ERRATA for
PE Mechanical HVAC and Refrigeration Questions and Solutions
ISBN: 978-1-932613-76-6
Copyright 2016
Errata posted 03/26/2018

ERRATA for
PE Mechanical Engineering: HVAC and Refrigeration Practice Exam
ISBN: 978-1-932613-76-6
Copyright 2016
Errata posted 11/30/2017

Question 136, p. 30:

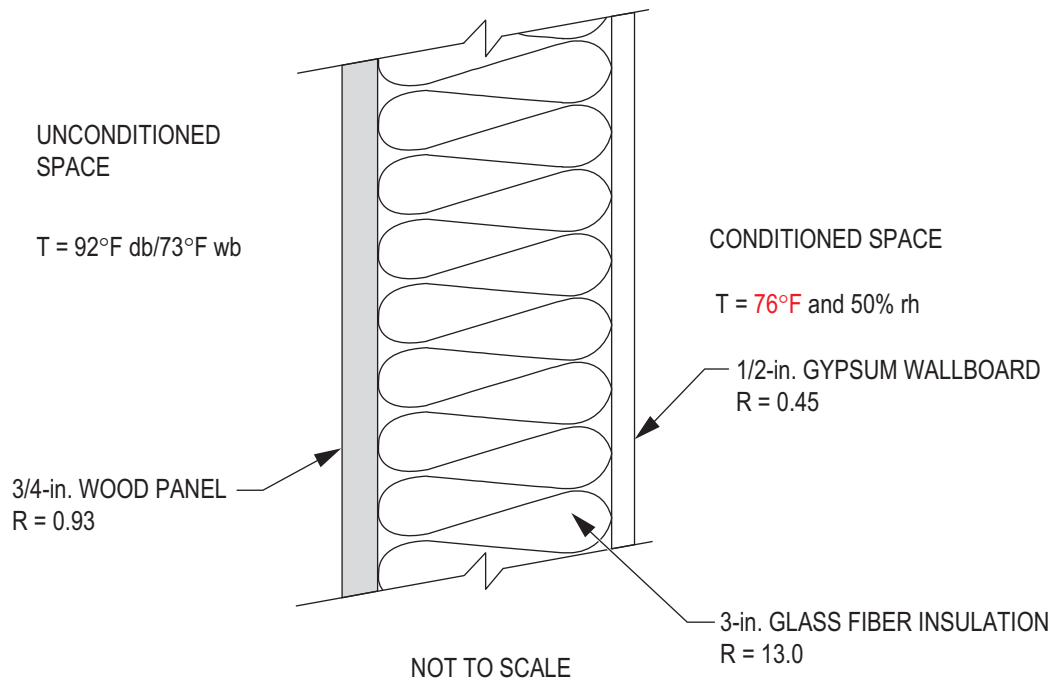
A building air-conditioning system requires 10,000 cfm of outside air for ventilation. An enthalpy wheel, as shown, exchanges both sensible and latent heat energy to reduce the design load on the building refrigeration system. If the enthalpy wheel has 2% losses, the reduction in design load (tons) on the refrigeration system is most nearly:

- (A) 8.4
- (B) 19.1
- (C) 24.4
- (D) 54.2

Solution 136, p. 84:

THE CORRECT ANSWER IS: (B)
